PRODUCT CHANGE NOTIFICATION

ISOMOV™ HYBRID PROTECTION COMPONENTS

Select Bourns® IsoMOV™ Hybrid Protection Components Tape Packaging Dimension Changes

GDT2213 REV2

Carton carrier pitch and sticky tape (BEFORE)

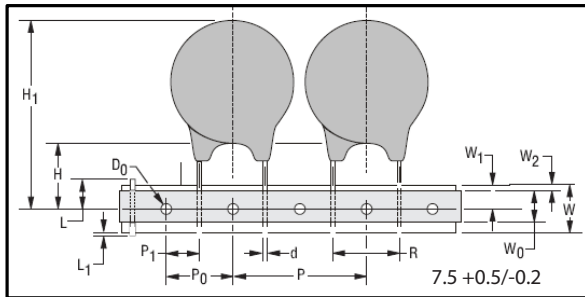
Riverside, California – June 16, 2022 – In the spirit of continuous improvement, effective May 27, 2022, Bourns changed the tape packaging specifications for select [IsoMOV™ Hybrid Protection Components](#). The reel core diameter has been increased to enhance the reel stability when fully loaded. The component pitch (R), while mounted in the carton carrier, has been updated, keeping the nominal dimension and increasing the tolerance symmetrically. In this same line, the carton carrier sticky tape has been changed from a single wider version tape to a thinner double tape. Finally, select part number Minimum Order Quantities (MOQ) and Multiples (MULTs) have been updated for better accommodation in the new reel design. A list of affected part numbers is included below.
